PROPOSED HIGH SCHOOL Old Lyme, Connecticut

ENVIRONMENTAL REVIEW TEAM REPORT
ON THE
PROPOSED HIGH SCHOOL
OLD LYME, CONNECTICUT

JANUARY, 1975

SITE PLAN

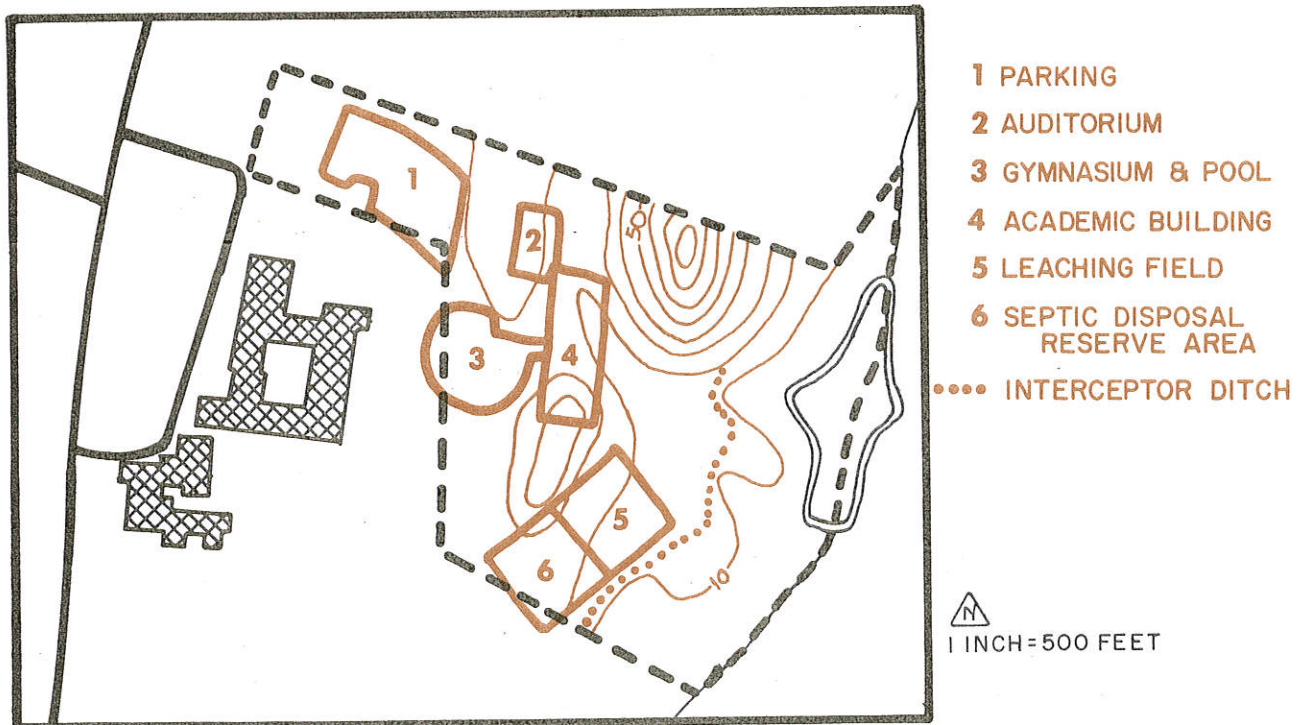
Waste disposal will be by means of a subsurface sewage disposal system (approximate location of leaching fields is shown on Site Plan, page 4). Although half of the site has adverse factors which impose severe restrictions for sewage disposal purposes, there is a section of the property which appears suitable for this use. The area is located on the southeastern side of the property west of the pond and Duck River. Visual observations, detailed soil survey information (soil 20BC), and a previous investigation by the state and local health departments (May 1974) indicate the soil to be well drained, consisting mostly of sandy material.

While some filling and regrading of that portion where sand and/or gravel has been excavated will be needed, there does not appear to be a problem with high ground water or maintaining more than the required separating distance from the pond, stream, and wetland areas. From the layout of these leaching fields that was shown to the team, no serious problems with grading and installation are expected. The trenches installed on the fills would probably cave in easily. Due to the terrain it appears that precautionary measures should be taken during the course of grading and installing the sewage system to protect the waterway from possible surface runoff and ensuing siltation.

Erosion and sediment control plans have been included in the wetlands application. The idea on the plans is to construct or place sediment traps at several locations along the interceptor ditch (see location on Site Plan on page 4). It has been suggested that constructing a designed silt trap (sediment basin) in the main drainage way would be more effective and need less maintenance than the baled hay erosion checks. The interceptor ditch would outlet into the silt trap. Its location, as shown in the inland wetlands application, is strategically located and should prove effective. If construction permits, it is suggested that the grade in the ditch be no steeper than a one foot drop in a hundred feet (1% grade). The use of baled hay erosion checks within the interceptor ditch could be useful in reducing the velocity of runoff into the silt trap and in removing some of the sediments. With any erosion control practice, proper maintenance is necessary for the measure to be effective.

The plans for a parking lot in the northwest end of the property involves a wetland area. The parking lot would be constructed on fill, but care should be taken to prevent frost heaves or settling. The stumps and organic material should be removed prior to filling so that the fill can be properly compacted.

In developing the site, a carefully designed drainage system will be necessary. The auditorium and classroom building will block a natural drainage way and the parking lot will encroach further upon another wetland area. Drainage from the surrounding hills will also need to be controlled in the vicinity of the buildings.

It was noted on the plans that there is a considerable distance from the parking lot to the auditorium and gym. If these are to be used for community events, some provisions should be made for handicapped and elderly individuals.
